Architect's Supplemental Instructions

Architect's ASI No: 035

Project:
Webster University
Interdisciplinary Science
Building

Discipline Code: 03 Electrical

SHEET E0101.A LEVEL 01 AREA A FLOOR PLAN – ELECTRICAL

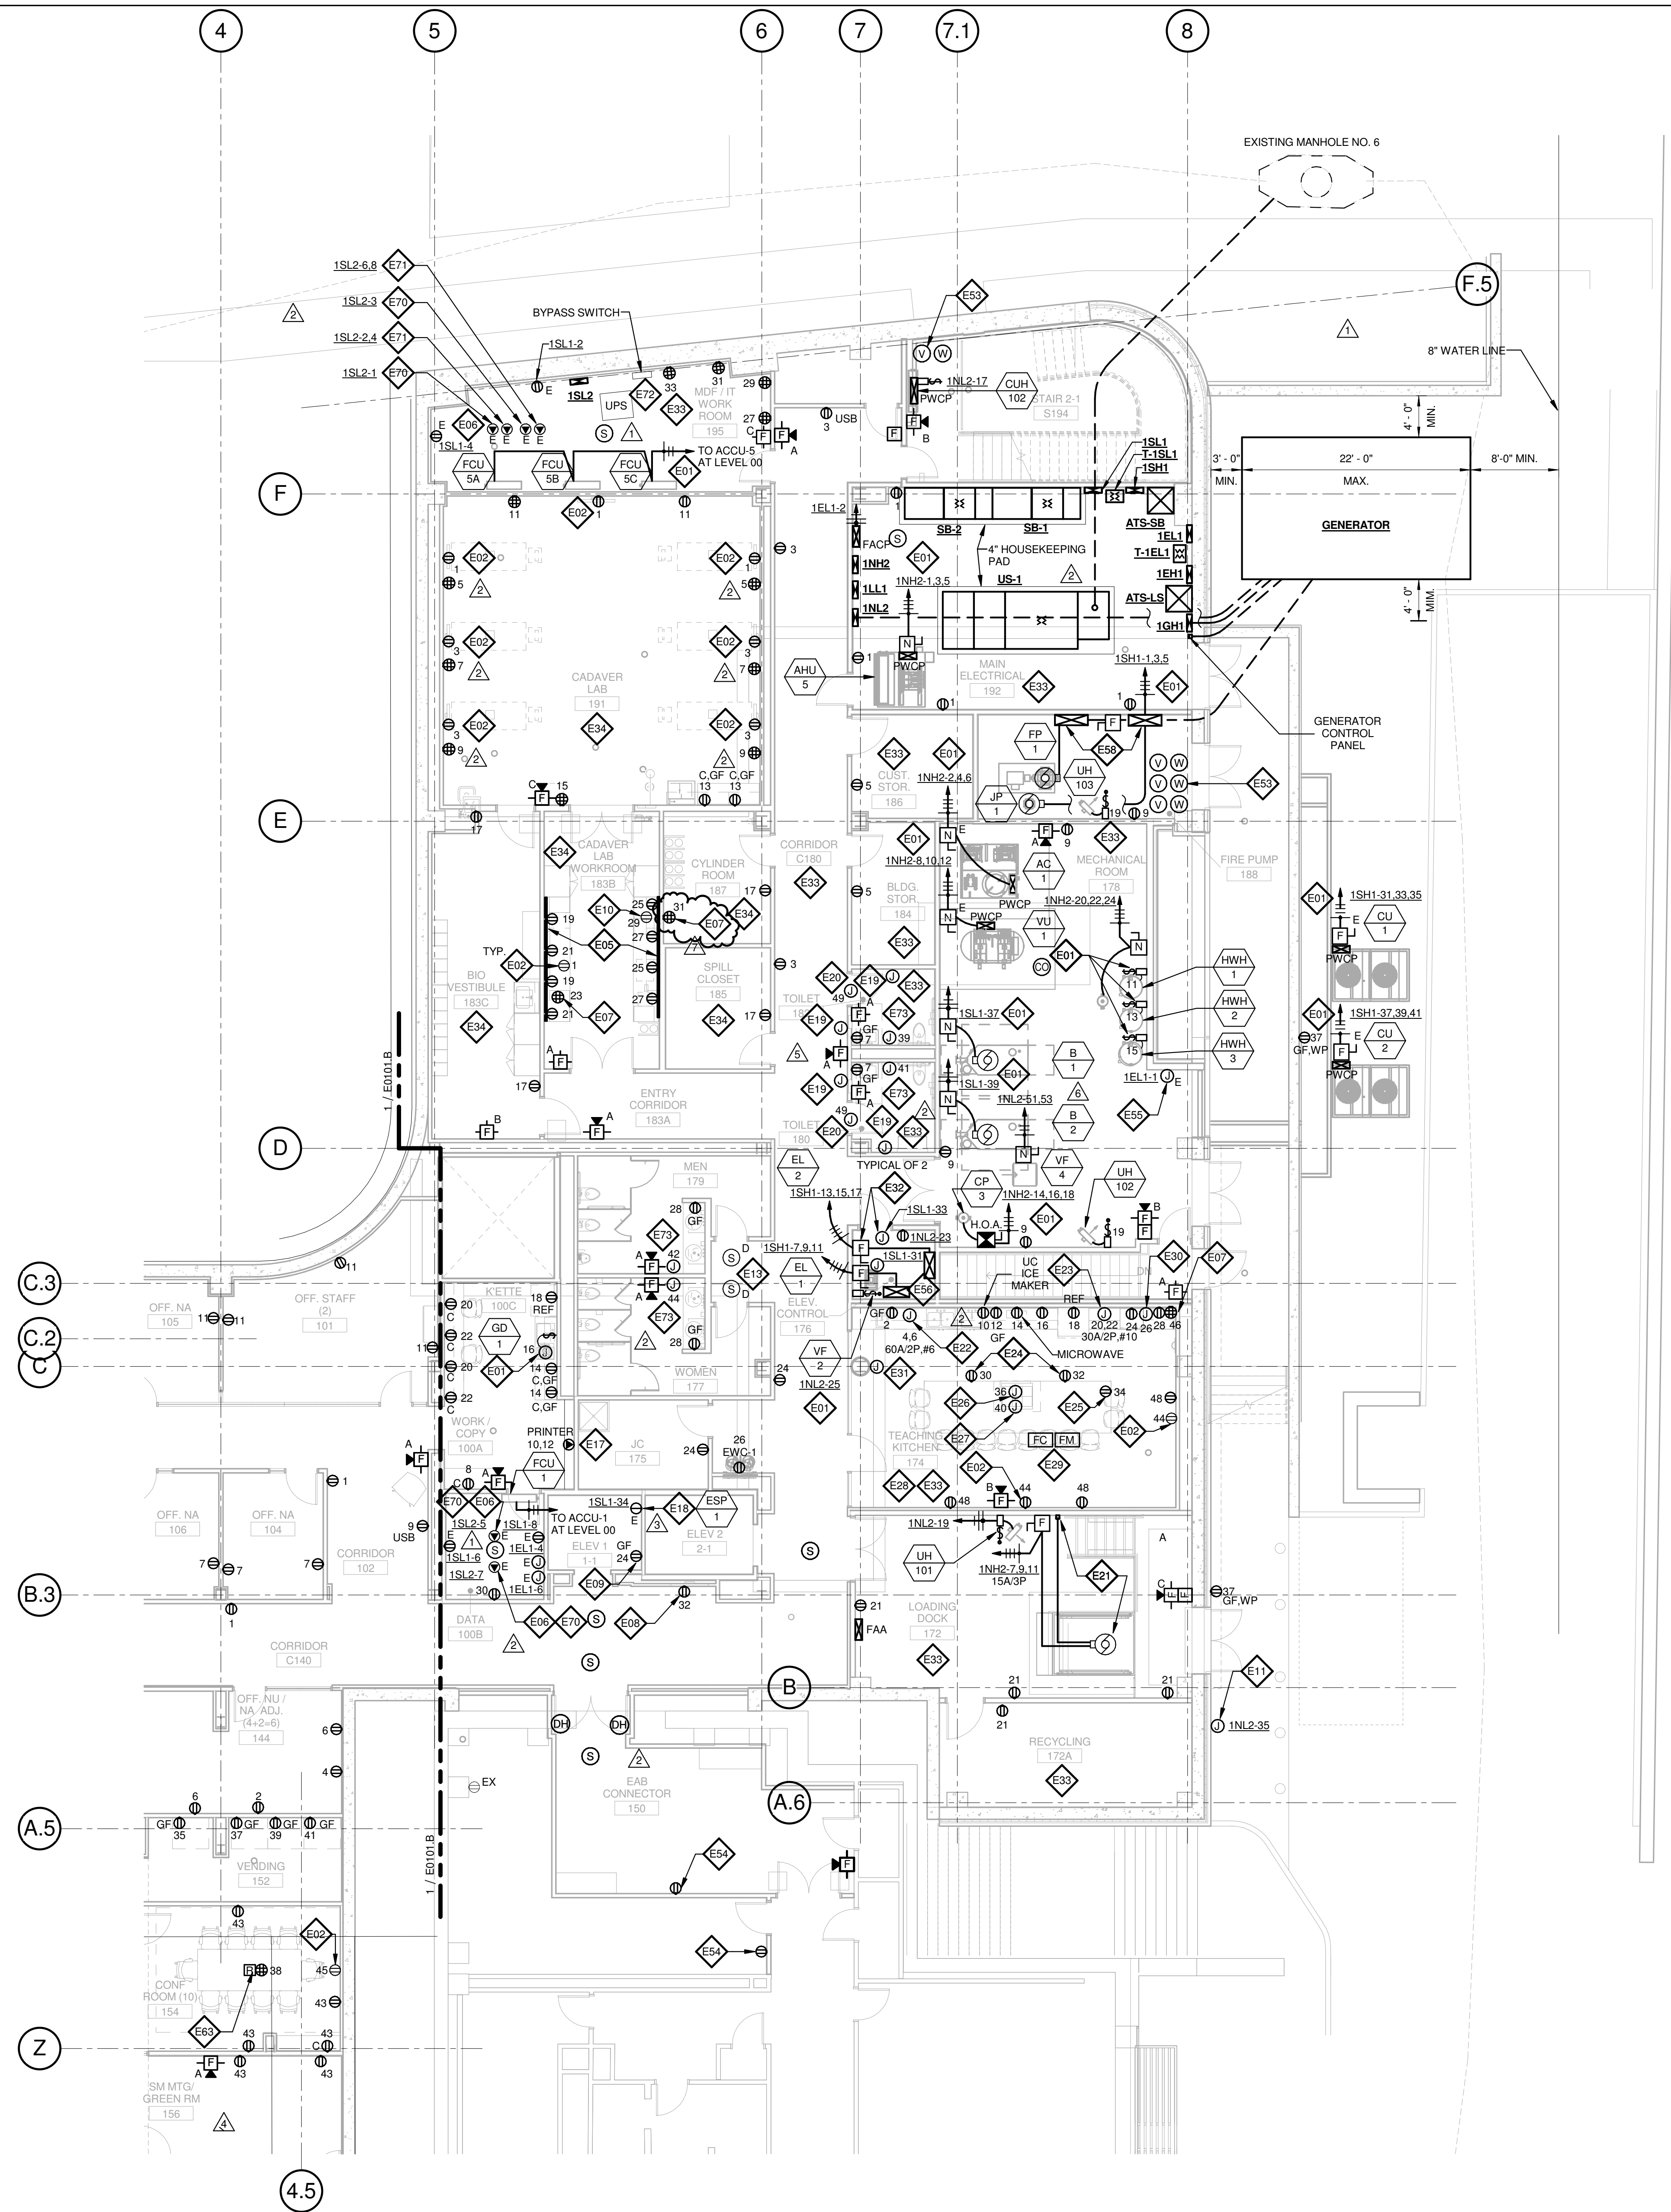
- Add quadruplex outlet and associated circuit in Cylinder Room 187 for AV rack.

**LEVEL 01 AREA B FLOOR
PLAN - ELECTRICAL &
AUXILIARY**

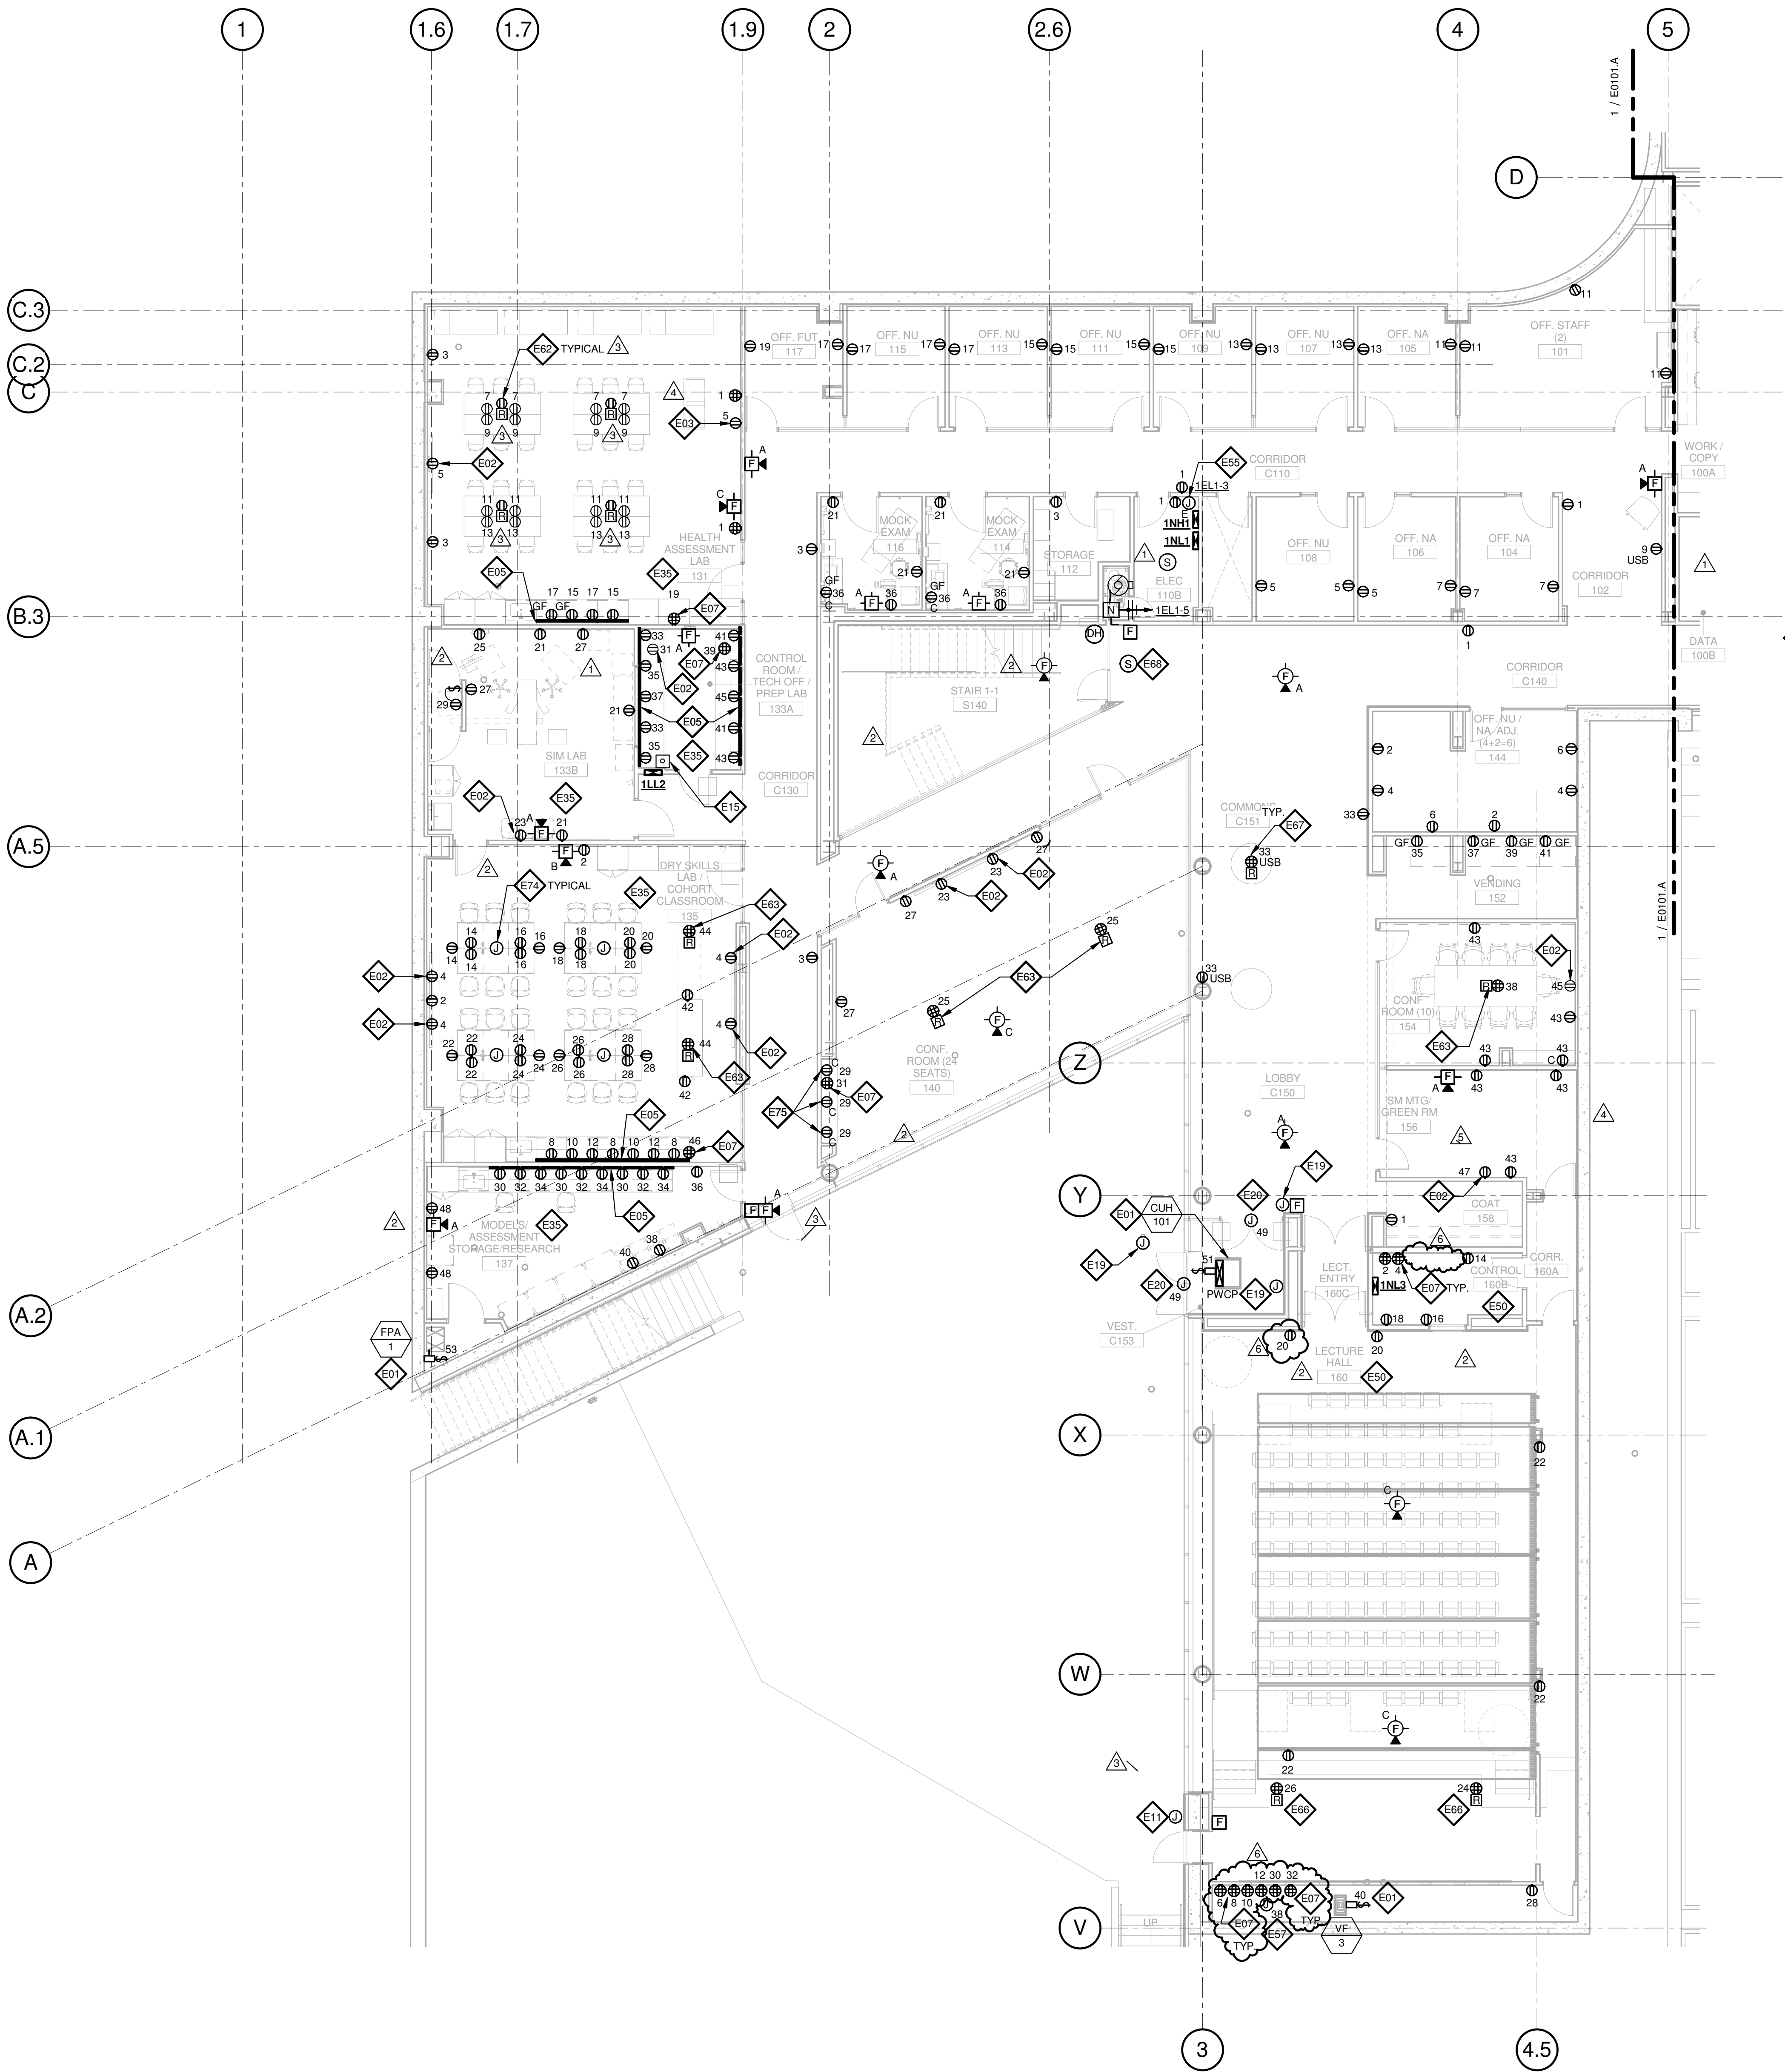
- Add duplex receptacle in Lecture Hall 160 and connect to adjacent circuit.
- Move four quadruplex receptacles and associated circuits from Control 160B to Lecture Hall storage room.
- Add two quadruplex receptacles and associated circuits in Lecture Hall storage room for AV rack.

Drawing Title:
**LEVEL 02 AREA A FLOOR
PLAN - ELECTRICAL &
AUXILIARY**

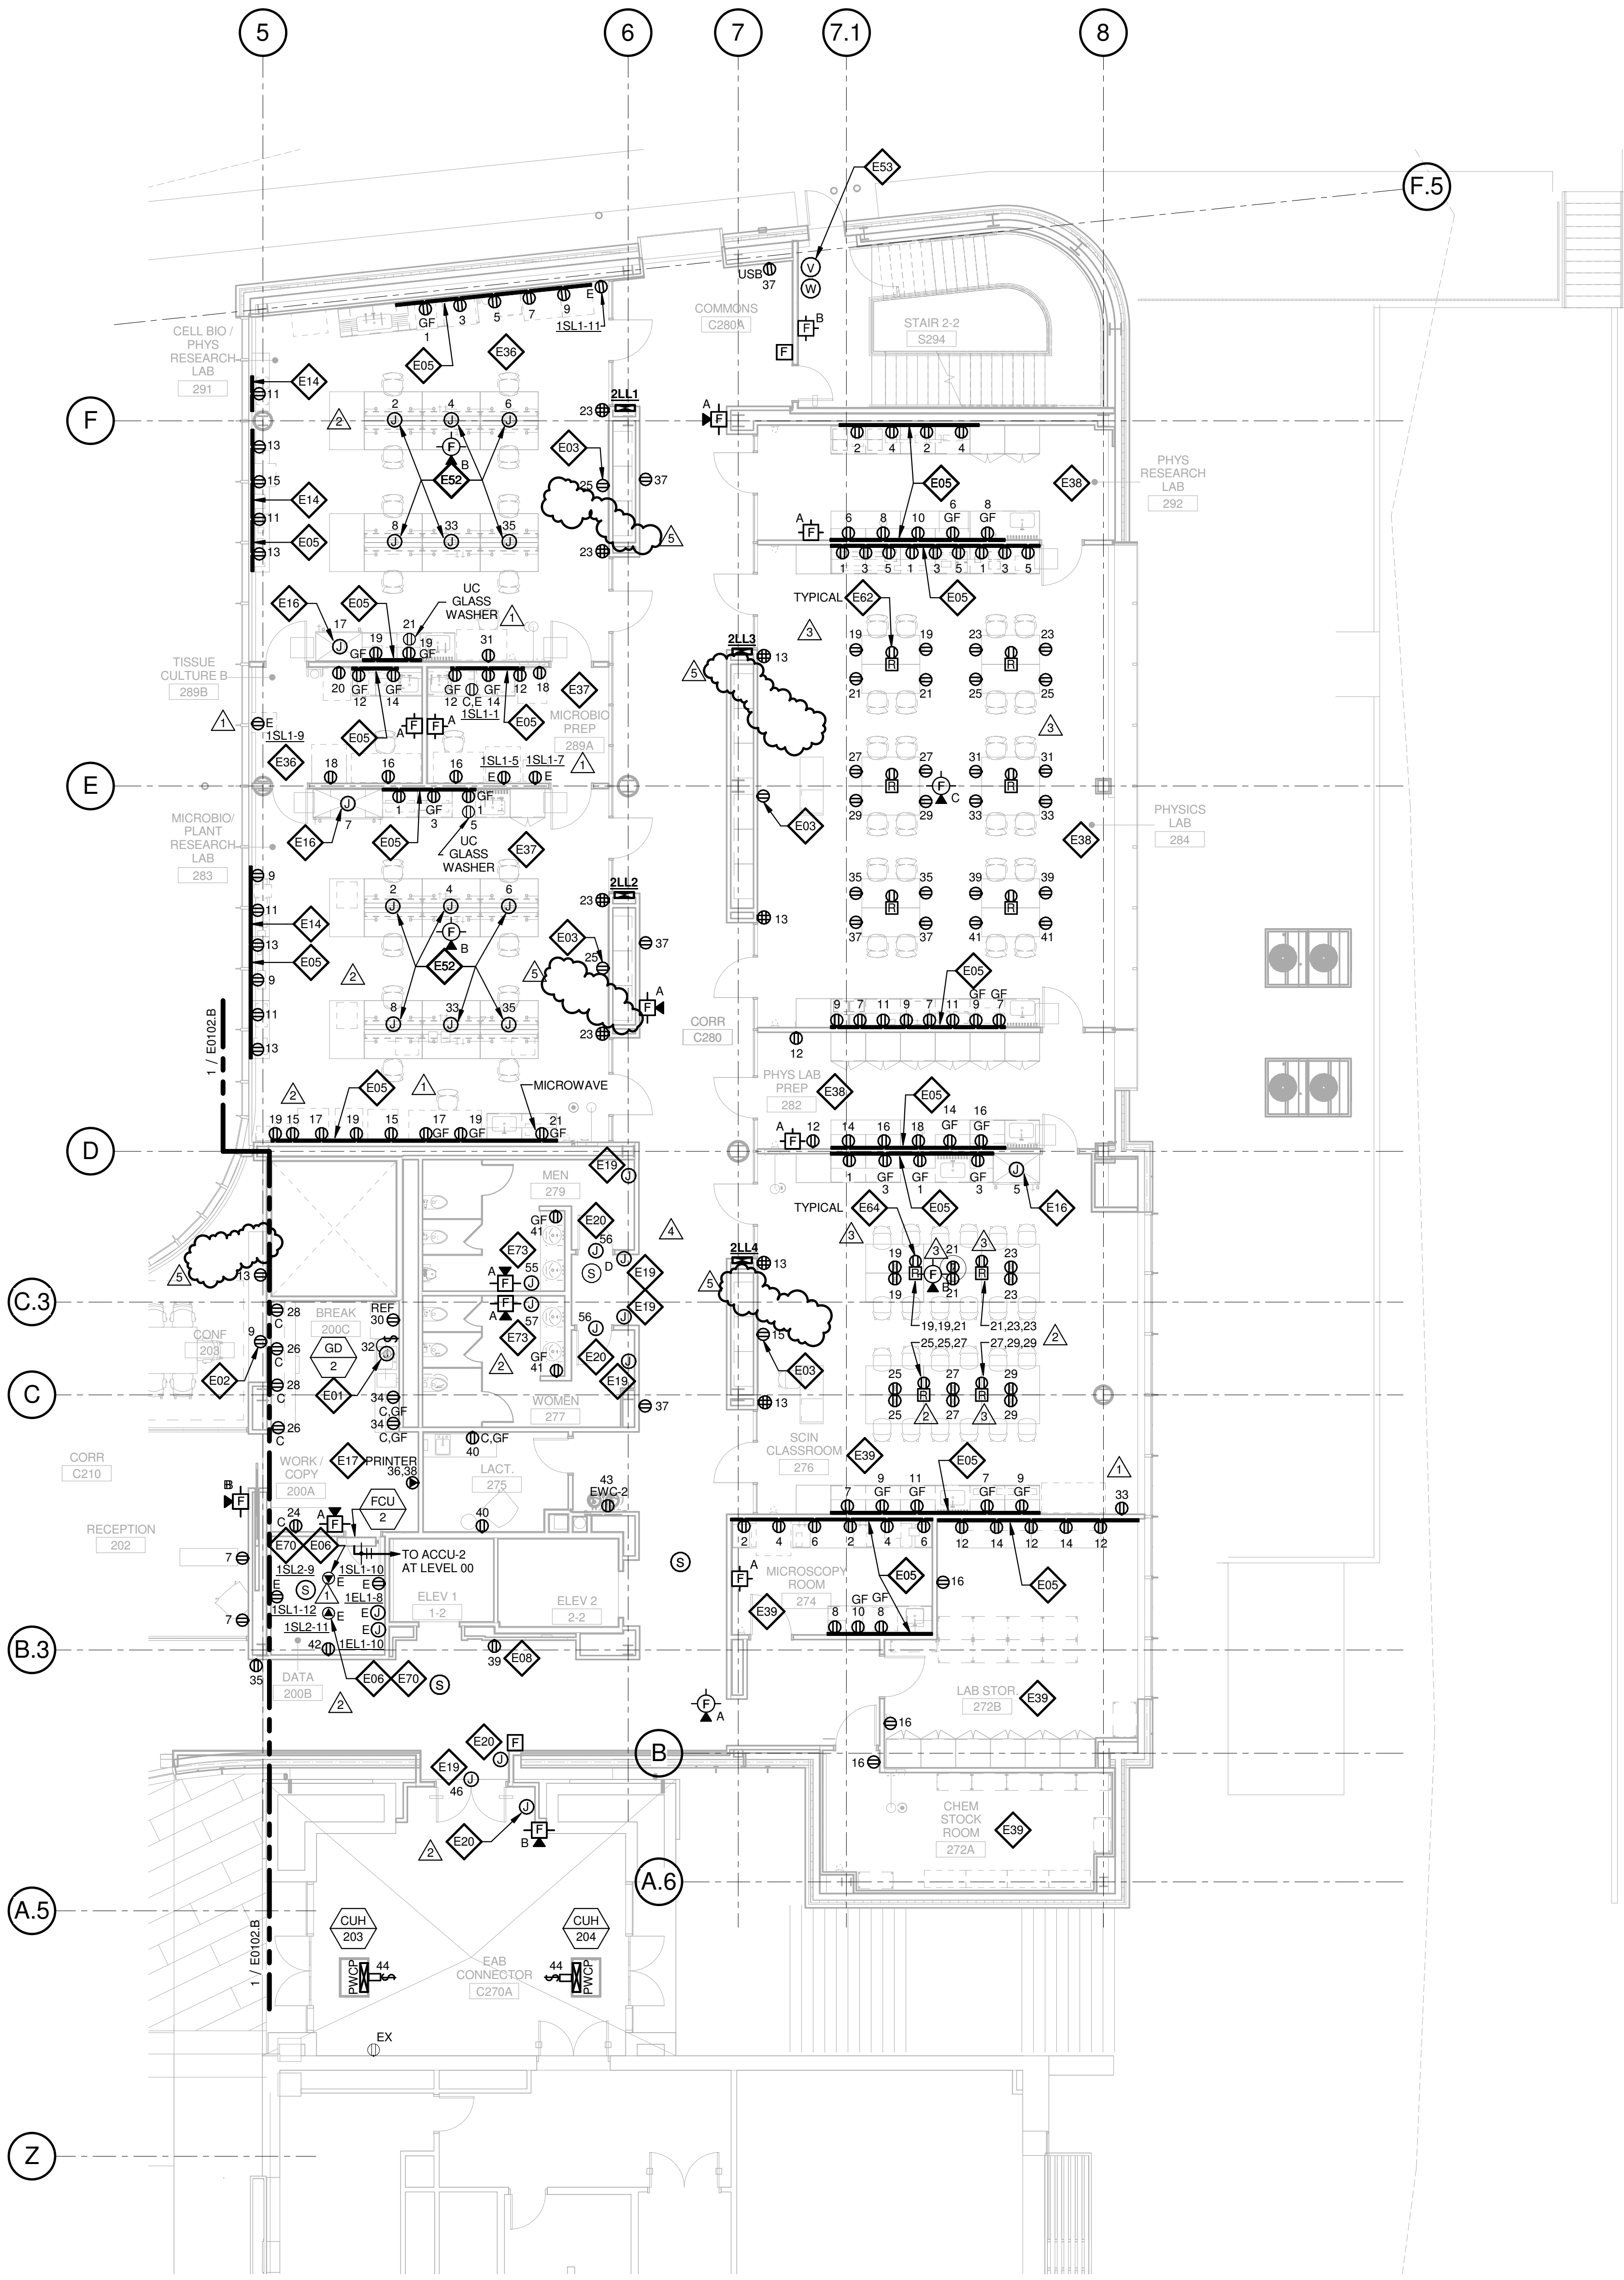
- Delete AV rack quadruplex receptacle and associated circuit in Classroom 276.
- Delete AV rack quadruplex receptacle and associated circuit in Lab 283.
- Delete AV rack quadruplex receptacle and associated circuit in Lab 284.
- Delete AV rack quadruplex receptacle and associated circuit in Lab 291.
